AMENDMENT OF SOLICITATION/MODIFICATION OF CONTRACT				1. CONTRACT ID CODE	PAGE 1	OF PAGES 6
2. AMENDMENT/MODIFICATION NO. <div style="text-align: center;">A001</div>		3. EFFECTIVE DATE <div style="text-align: center;">06/28/12</div>		4. REQUISITION/PURCHASE REQ. NO. <div style="text-align: center;">AC-12-03732</div>		5. PROJECT NO. <i>(If applicable)</i>

SUBJECT: Addendum No. One to the Specifications and Drawings for the waterproofing of the ATCT in Sanford, FL.

This Addendum modifies and takes precedence over the original Specifications and Drawings and forms a part of the contract documents.

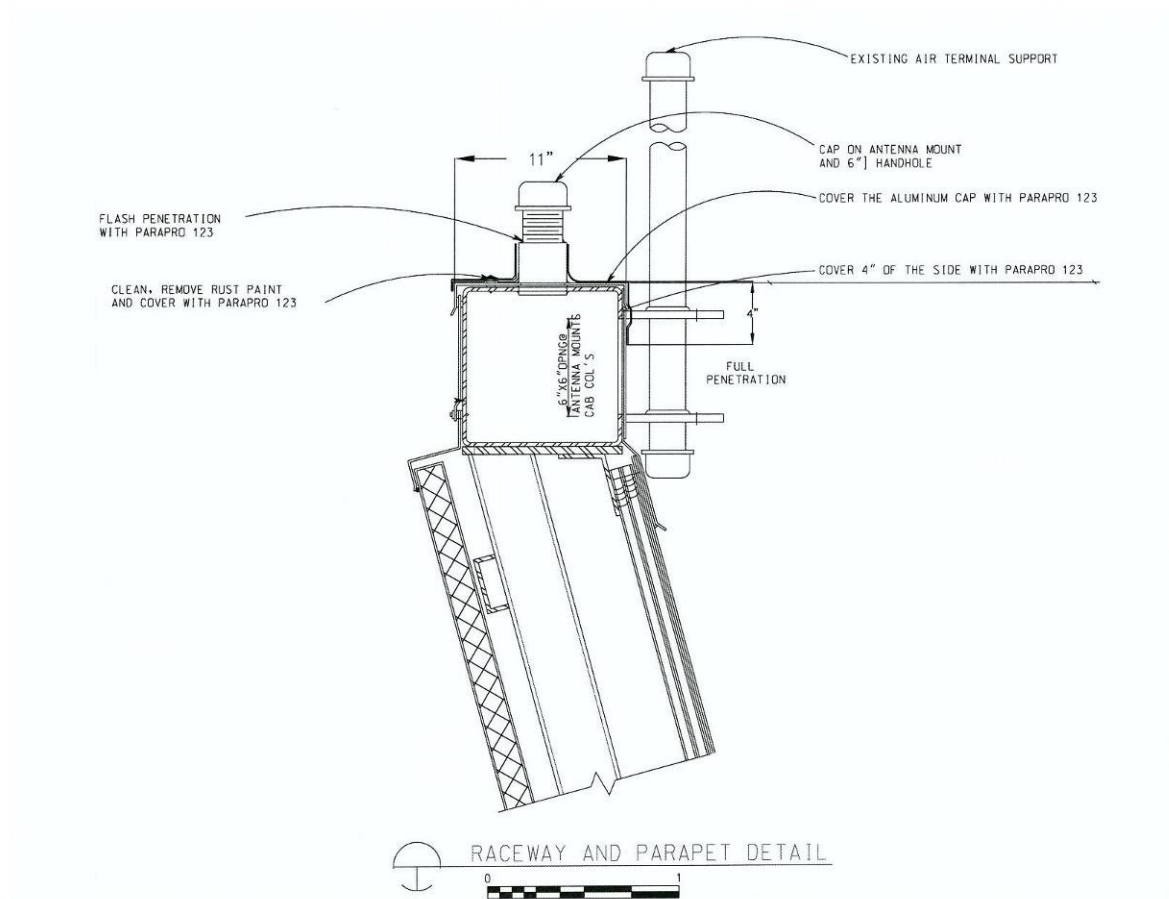
Scope: Cab roof parapet wall cap needs to be cover with reinforce liquid coat resin. (Parapro 123by Siplast) As show in the enclose detail.

8" around any penetration, seam and rusted pinholes. The surface need to be clean rust, old paint, grease or any contaminant. The surrounded eight inches around this of this area need to be bare metal.

The Metal Cap must be clean, of dry, loose material or any foreign material that would be detrimental the adhesion of the catalyzed primer. Remove rust or oxidation layer.

1. Lightly abrade surface prior to clean with pro prep.
2. Wipe down thoroughly with pro prep prior to coating. Allow 20 minutes of drying time after application before continuing. The coating should be completed within 60 minutes of cleaning with pro prep.
